# Central Planning Authority

**Minutes** of a meeting of the Central Planning Authority held on **August 16, 2023 at 10:00am in Conference Room 1038, 1st Floor, Government Administration Building, and Elgin Avenue.**

CPA/17/23

***Proposed Section 26***

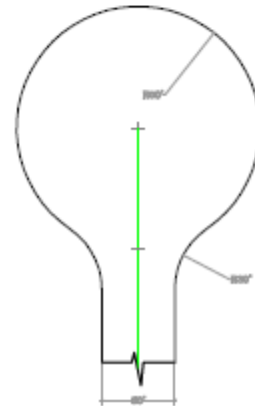
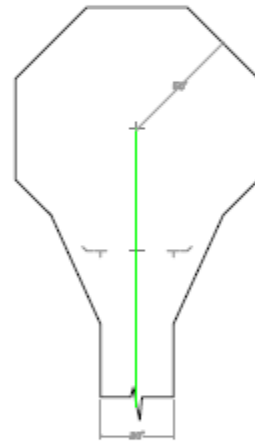
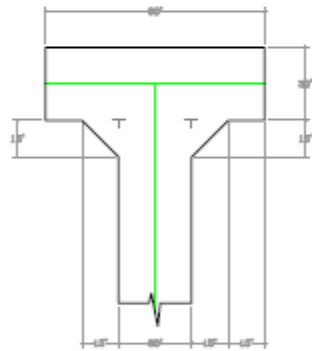
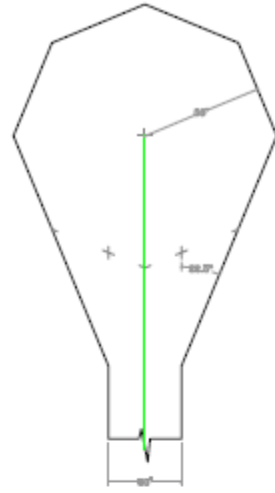
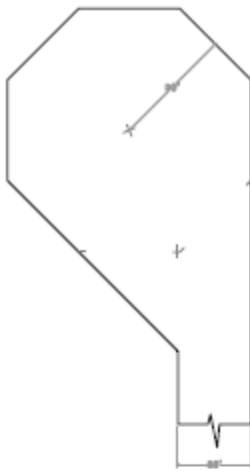
*The proposed section 26, as shown in the below schematic, is designed to come across the above block and parcel (25C146), utilizing the existing road parcel. Therefore, the proposed access will need to be built to NRA specifications.*

The NRA requests that the CPA have the applicant reconfigure the site noting the concerns below:

*Figure 1: Land cover map overlaid on proposed site plan, note the majority of the site is covered by tidally flooded mangrove forest and woodland (Source: DoE, 2023)*

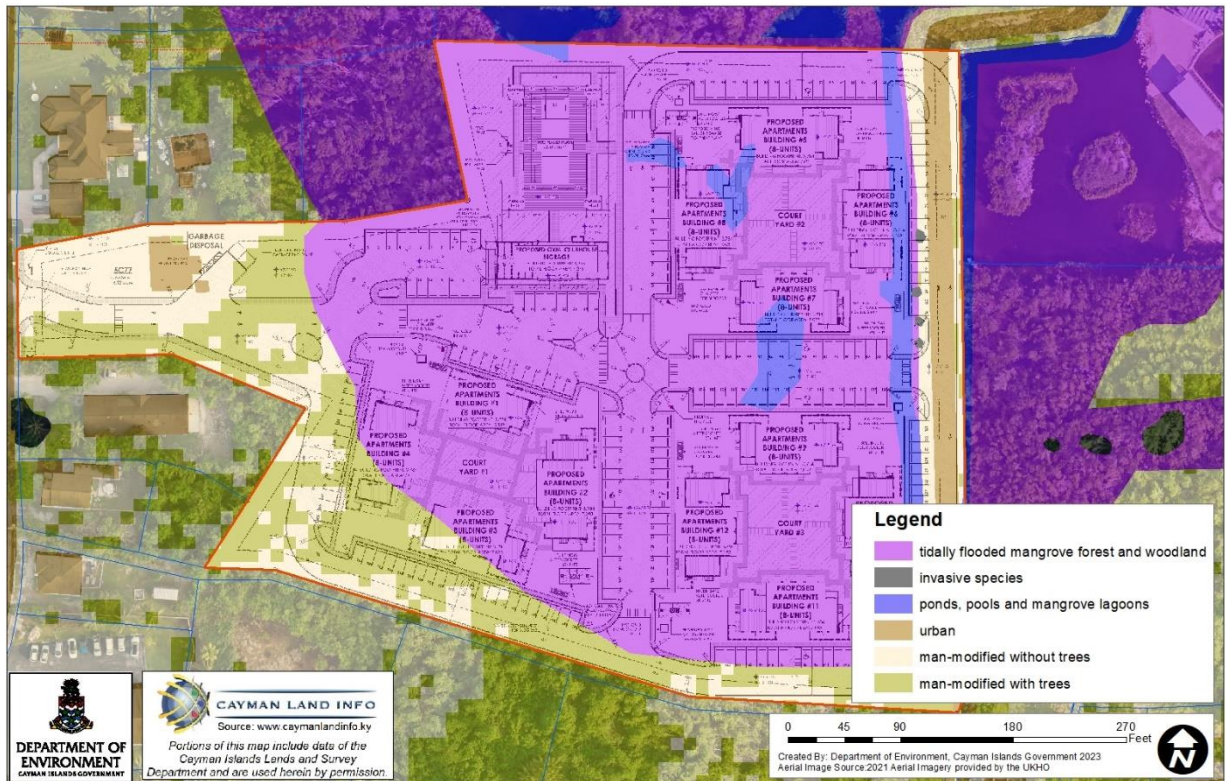
*The application site consists primarily of tidally flooded mangrove forest and woodland (refer to Figure 1) and features several ponds or pools.*

*We recommend that native plants are incorporated into the landscaping scheme. Native plants are best suited for the conditions of the site, including the temperature and the amount of rainfall. They are climate-appropriate and require less maintenance and irrigation. Landscaping with native vegetation also provides ecological benefits by creating habitat and food for native fauna such as birds and butterflies, promoting biodiversity and providing valuable ecosystem services. Stormwater management, flooding and drainage could all be greatly improved by retaining as much of the original wetland vegetation as possible.*

Figure 2: Site contours overlaid on 2018 aerial imagery (Source: LIS, 2018)

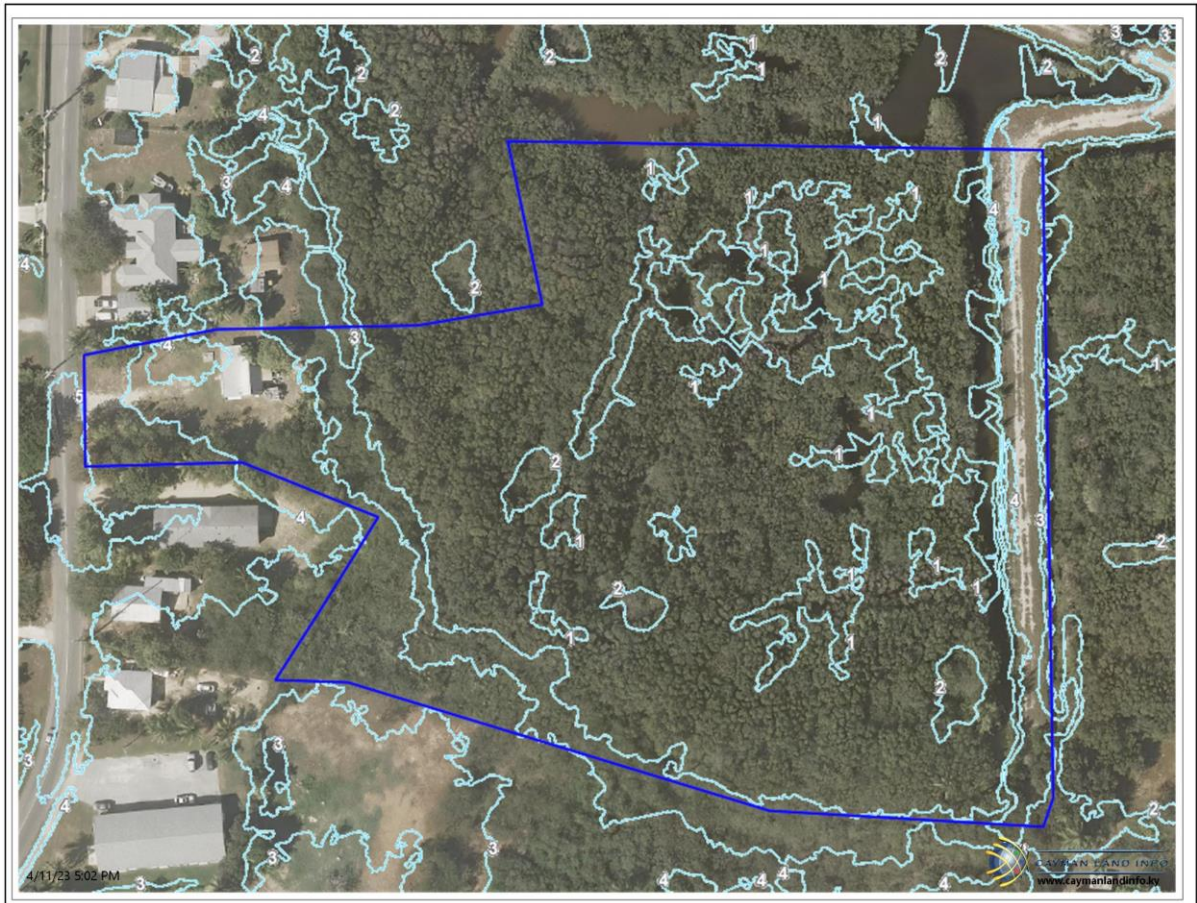
*The site is very low lying, averaging around 1 foot above Mean Sea Level (refer to Figure 2). As such, drainage is likely to be a significant concern. The proposed site plan also features a large amount of hardscaping. We recommend that the applicant considers the use of porous or permeable paved surfaces in areas of hard standing such as the driveways and parking areas. The low elevation of the site should be considered during the production of a storm water management plan. The level of the site relative to the water table is likely to mean that commonly used drainage systems such as catch basins and deep wells are likely to be much less effective. The proposed site plan features a number of courtyard areas which could be used to incorporate sustainable urban drainage systems (SUDS) such as detention basins or retention ponds. This would not only improve the drainage of the site, but also the surrounding area.*

Figure 2. LIS 2018 Aerial Imagery showing the Application Site outlined in red

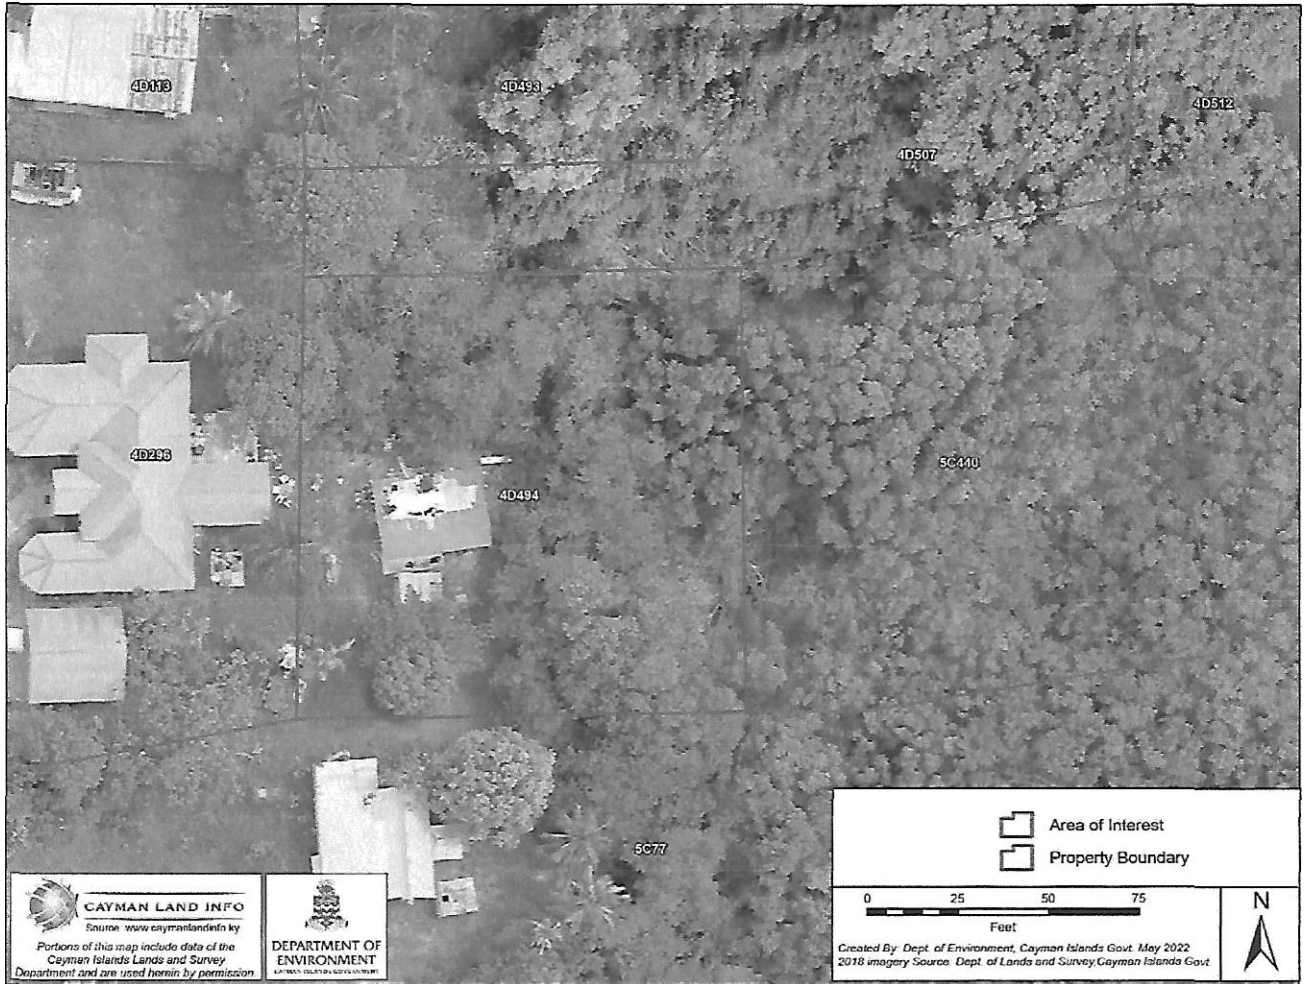
*The application site consists of a mixture of tidally flooded mangroves (primary habitat), and man-modified areas along with secondary growth as shown in Figures 1 and 2. -*

*Justification for the land clearing has not been included in the applicant’s submissions, therefore, the DoE considers the proposal to be speculative clearing. The DoE does not support speculative clearing of parcels prior to planning permission for development being granted. We recommend that applications for land clearing are presented along with the development proposal so that appropriate mitigation measures can be recommended, as there may be varying recommendations depending on the form and nature of the development being proposed. Once planning permission has been received, the DoE encourages applicants not to undertake land clearing until development is imminent to allow ecosystem services to continue to function until they are ready to begin construction.*

*However, it is noted that that there is any existing structure on site as shown in Figure 2 and that much of the site is man-modified with regrowth around the existing structure. Without a rationale for the clearing we would encourage applicants to retain as much native vegetation as possible to incorporate into the landscaping scheme. We particularly encourage the applicant to retain the*

**Figure 1: Aerial image showing the subject parcel in relation to the Salina Reserve and Colliers Wilderness Reserve. Base imagery source: Lands & Survey 2018 aerial imagery.**

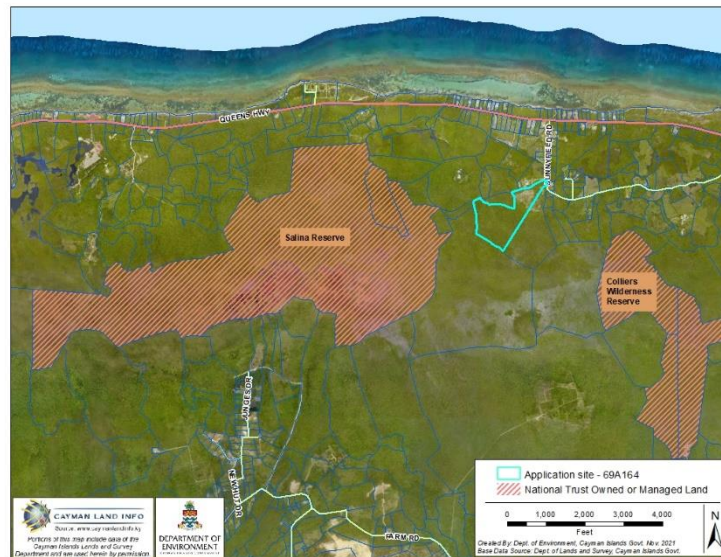
*The subject parcel and surrounding area currently serve as a wildlife corridor connecting two extremely important conservation areas: the **Colliers Wilderness Reserve** and the*

**Salina Reserve.** *Habitat loss and fragmentation are huge threats to our wildlife. Our native species have complex daily requirements that require them to travel safely from place to place, looking for nesting sites, food, water, a resting haven and shelter. With the increased urbanisation of the island, wildlife corridors are vital for the survival of our species. They bridge the gap between habitats which otherwise would be small and isolated and join them together. Linking core wildlife habitats helps to restore and preserve biodiversity, allowing movement between important habitats to maintain genetic diversity in wildlife populations. Without this, local extinctions can occur.*

*For these reasons, we do not support clearing beyond the already impacted area (see Figure 1). Heavy machinery can crush or bury iguanas and their nests. It is therefore crucial that **no mechanical clearing, excavation or filling takes place prior to DoE consultation**. Should minor clearing be required, mechanical clearing must not take place during the Blue Iguana nesting season (1 June – 30 September yearly) without DoE consultation.*
